**Staff Report to the  
Southeast Town Design Review Committee  
May 14, 2015**

**MPL2014-00039  
SUB2015-00021  
ITEM #1**

# LAUREATE PARK NEIGHBORHOOD CENTER

# PROPOSED CONCEPTUAL SITE PLAN

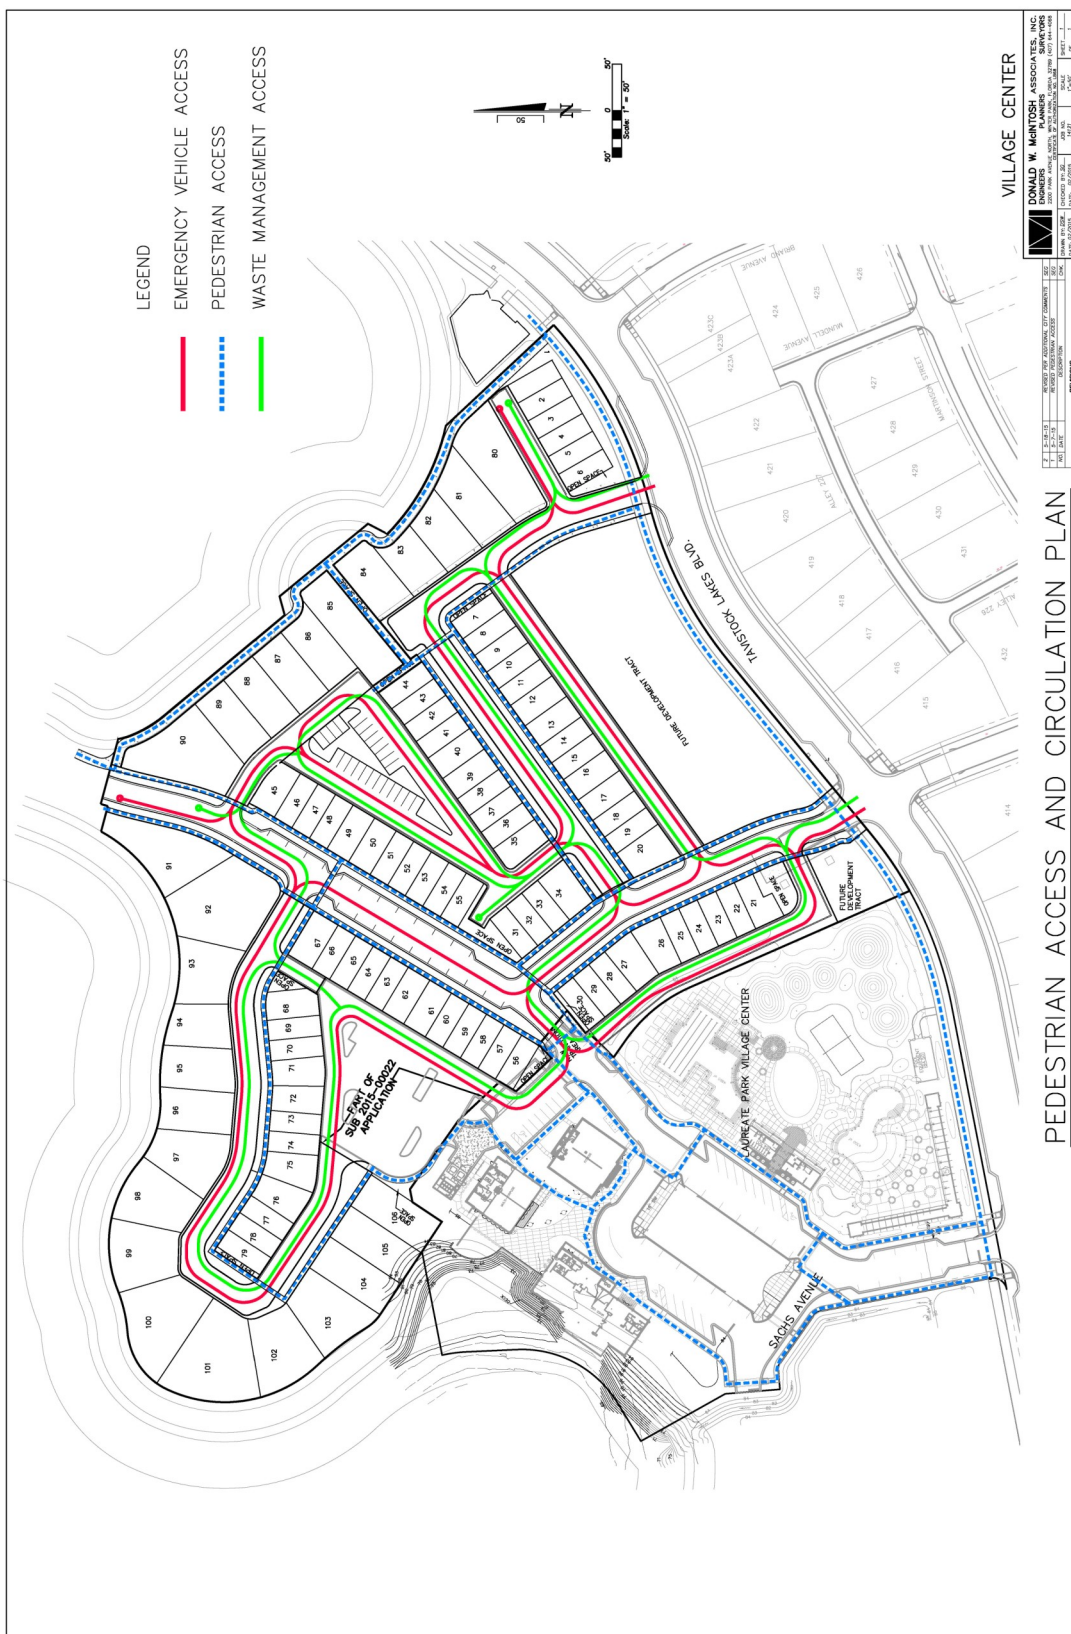
Updated  
to show  
public  
versus  
private  
streets  
per  
SETDRC  
approval

*Updated to  
show the re-  
vised pedes-  
trian access  
per SETDRC  
approval*

# PROPOSED STREET CROSS SECTIONS

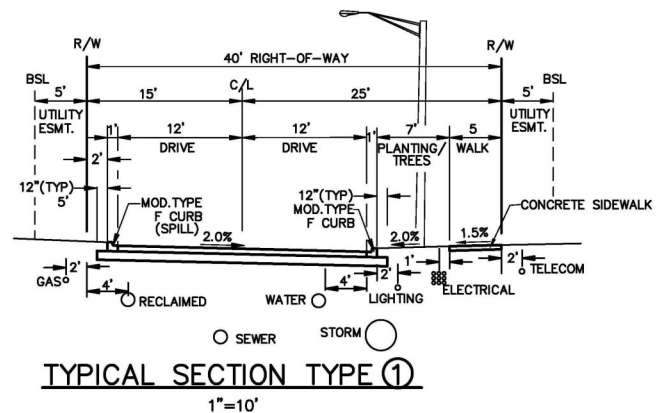
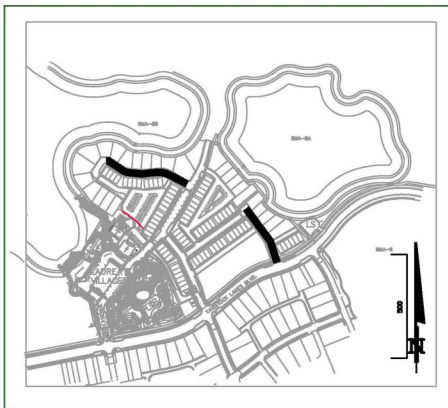
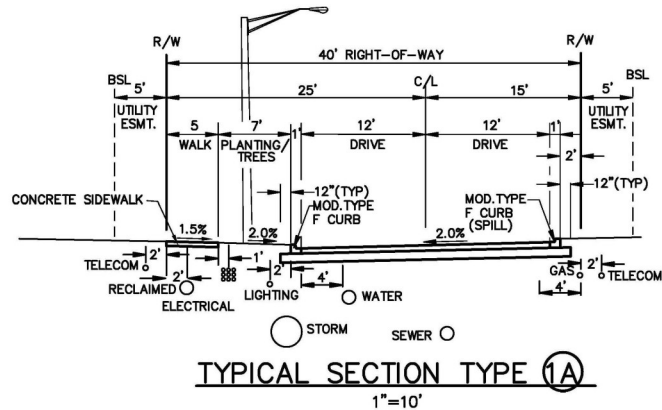
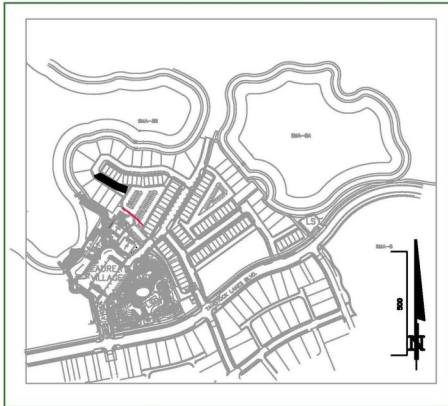
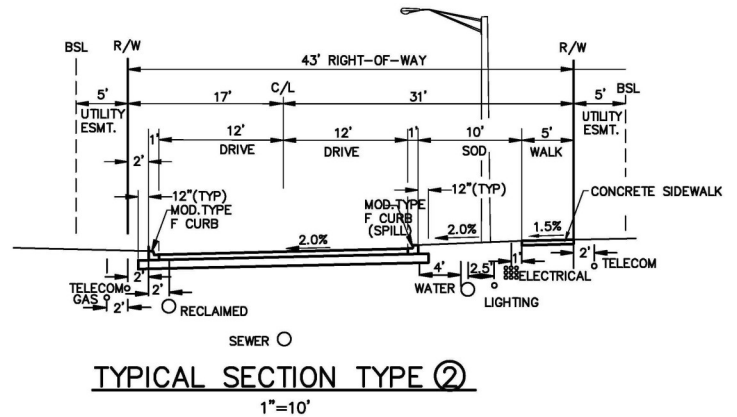
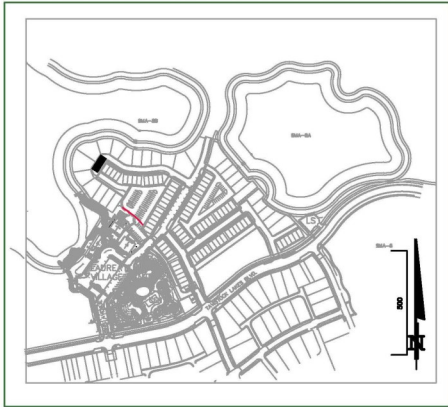
Typical Section Type 1 was updated per SETDRC approval.

**TYPICAL SECTION TYPE ④**

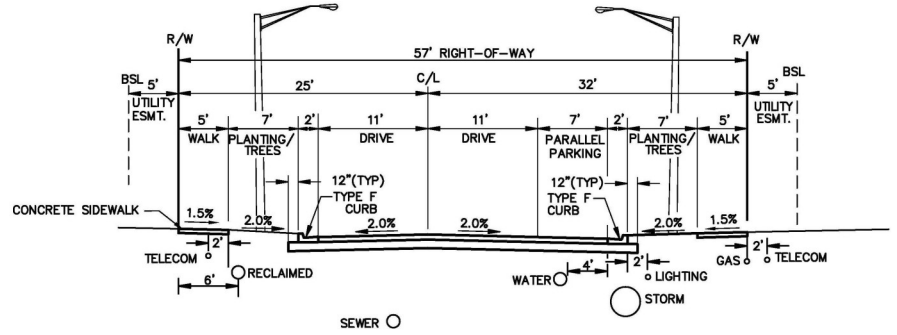
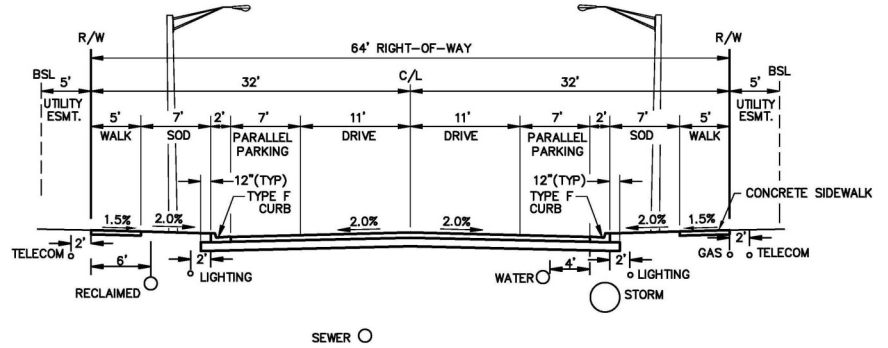
Typical Section Type 4 was updated per SETDRC approval.

# PROPOSED STREET CROSS SECTIONS

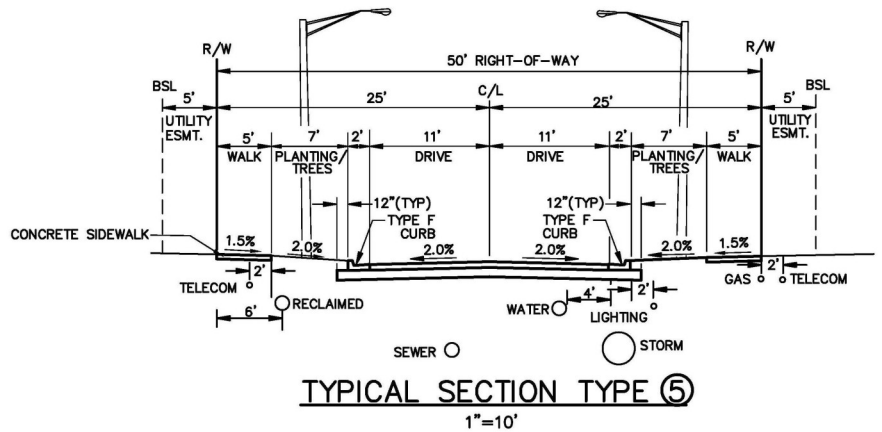
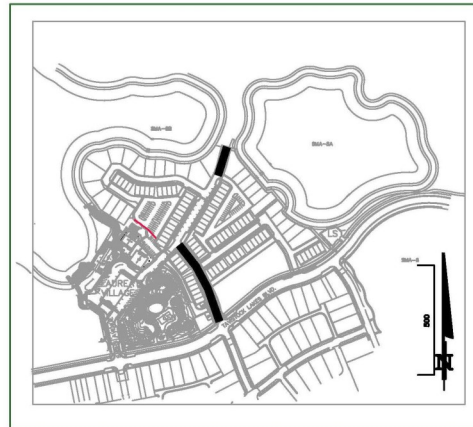
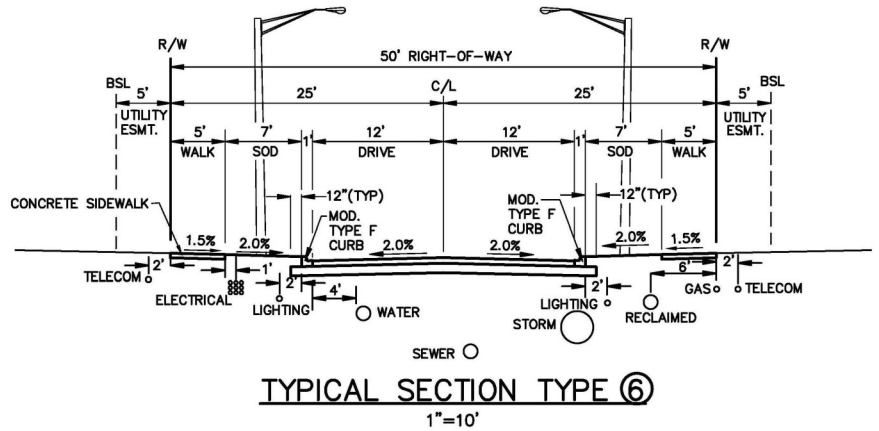
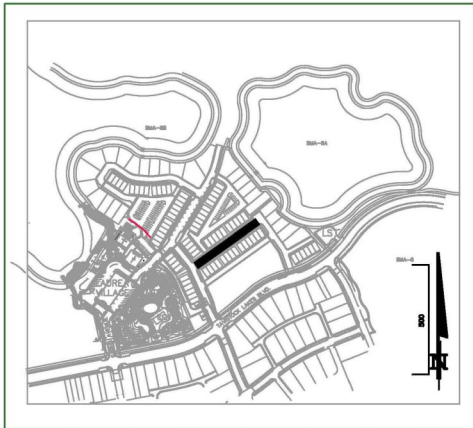
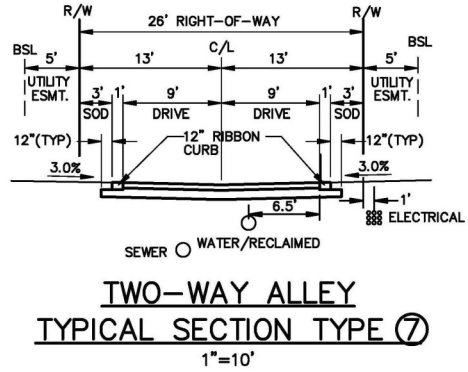
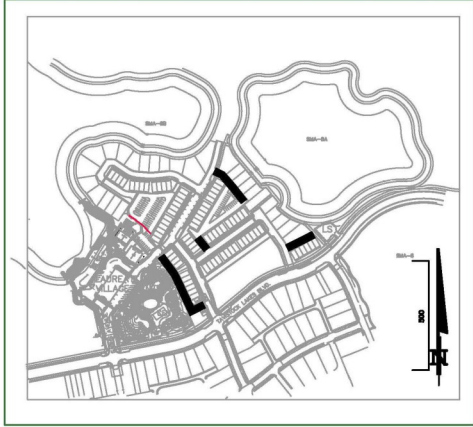
Typical Section Type 5 was updated per SETDRC approval.

# PROPOSED WATER/SEWER/RECLAIMED EXHIBIT

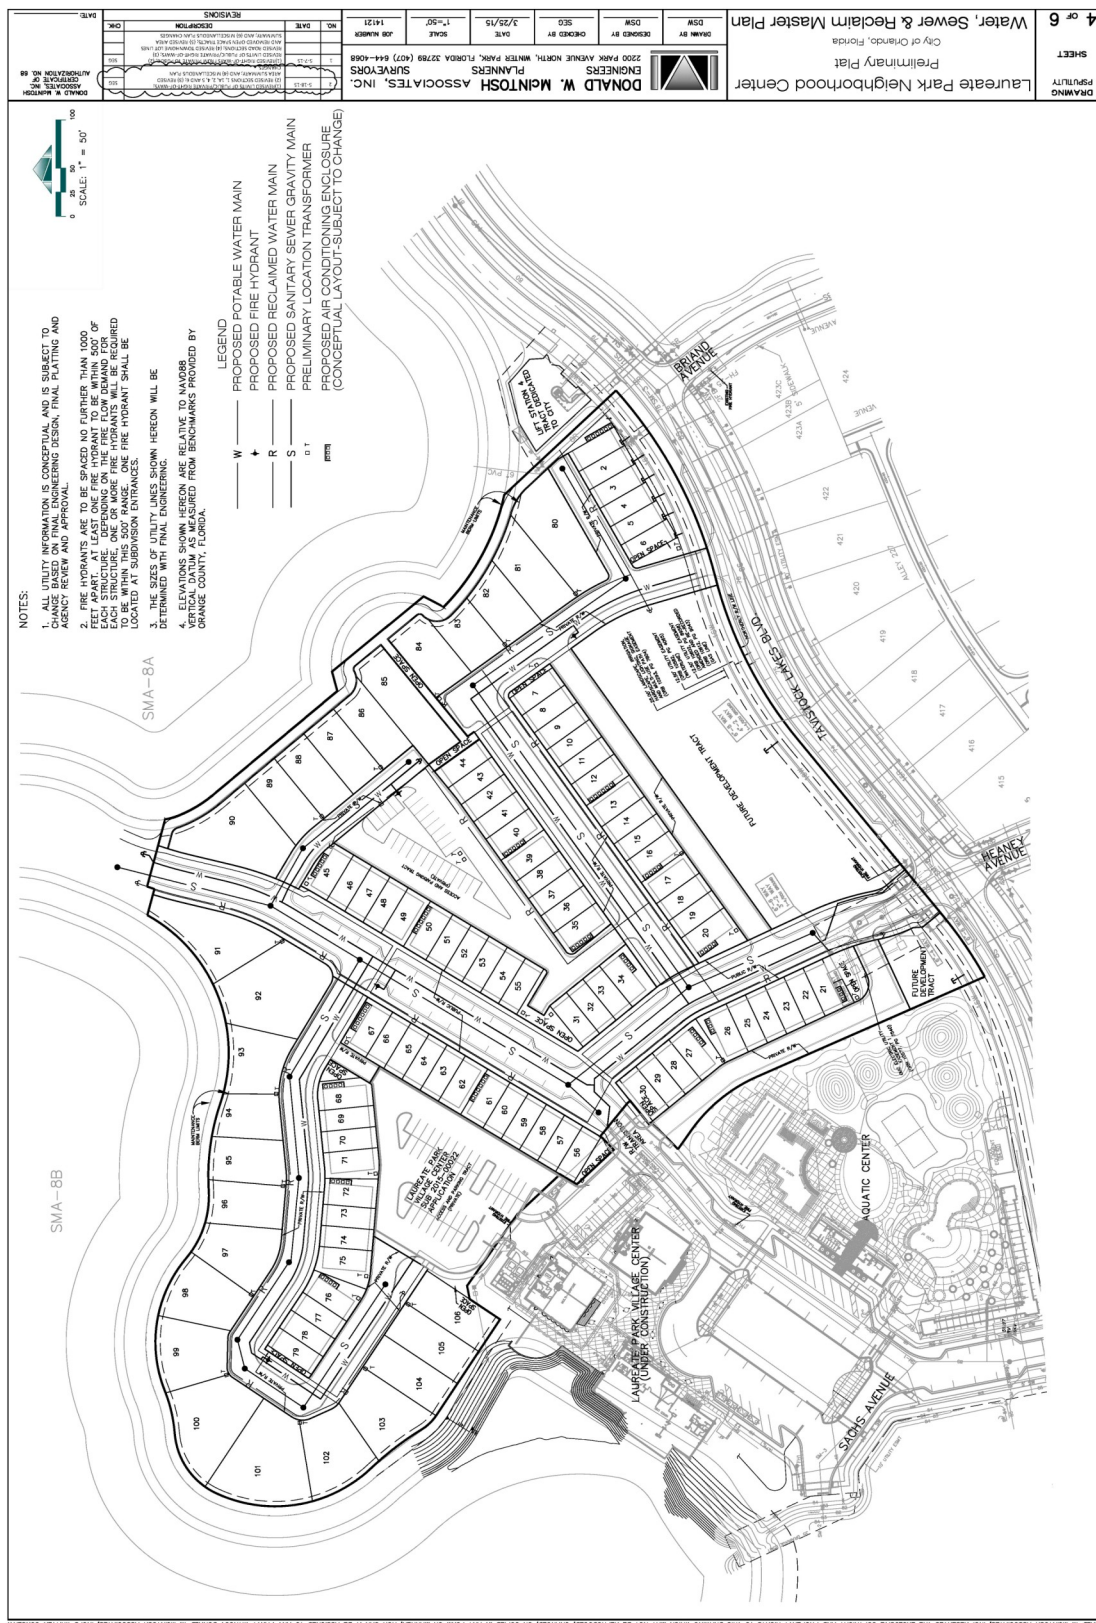
*Updated to show the revised public versus private streets per SETDRC approval*

# PRELIMINARY PLAT

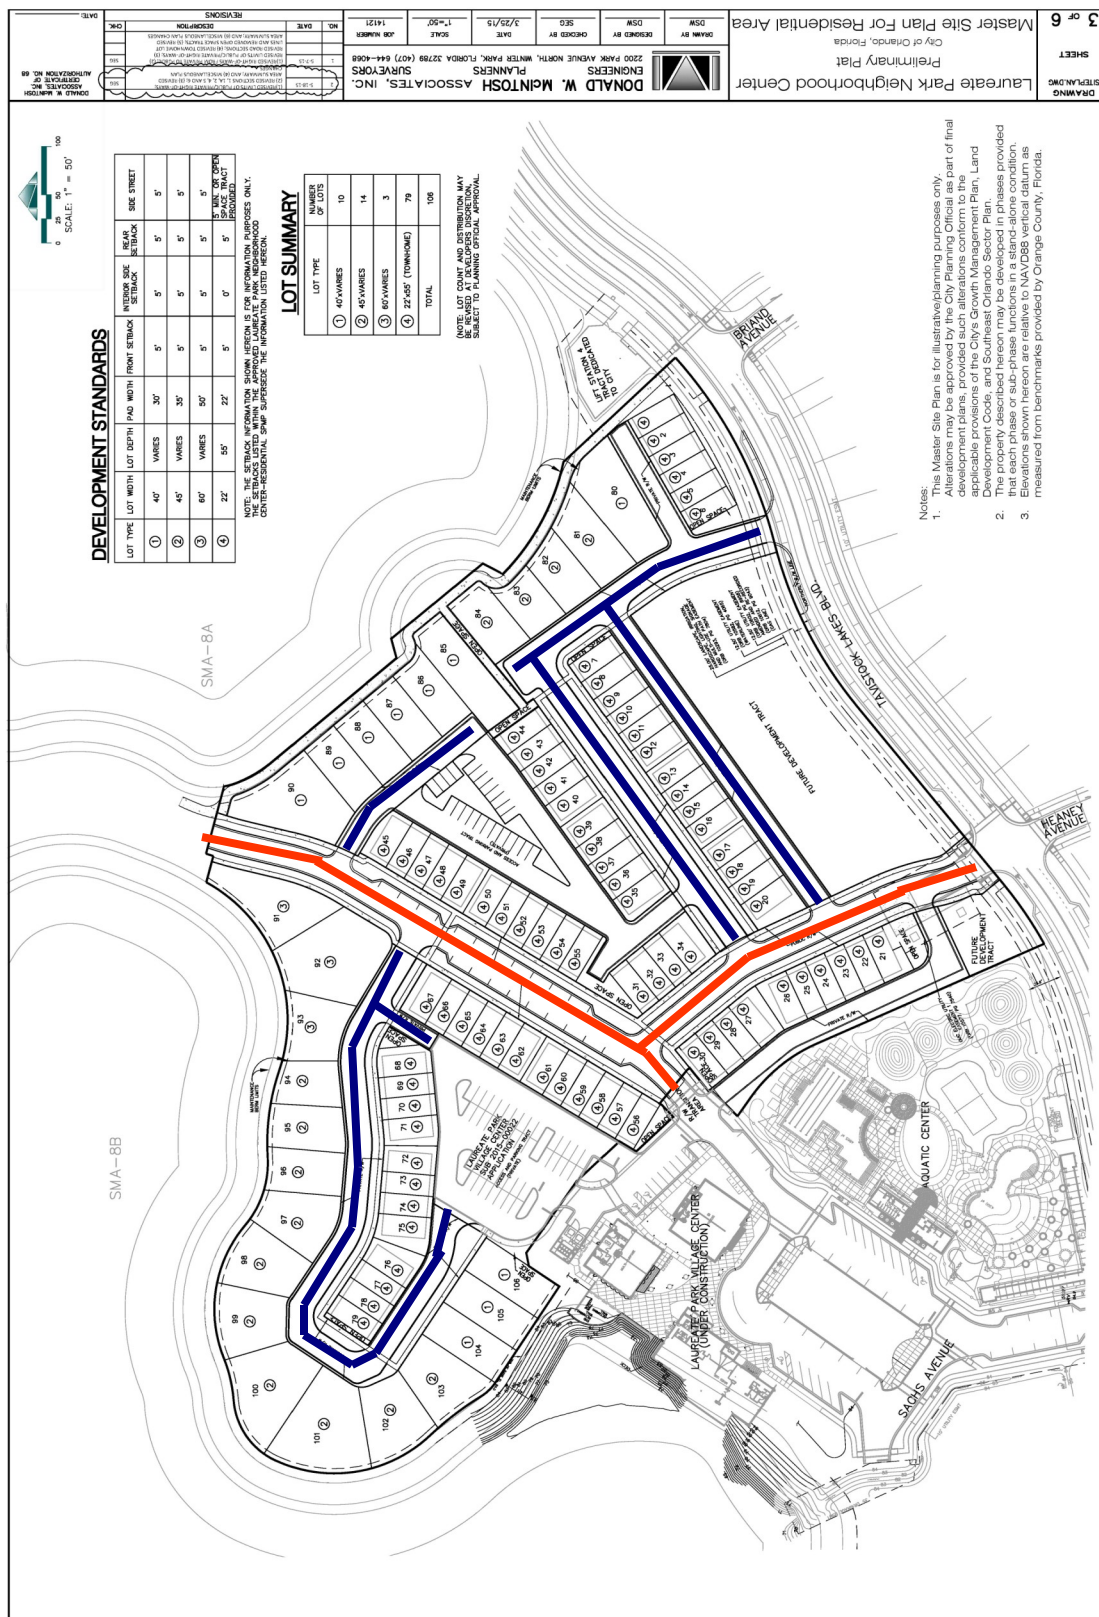
The proposed project is a major plat to subdivide the site into 106 lots. The plat must be amended to place the open space areas in lots or tracts.

*Updated to show the revised public versus private streets per SETDRC approval. Private street are highlighted in blue and public streets are highlighted in red.*

The plat must be amended to place the open space areas in lots or tracts.
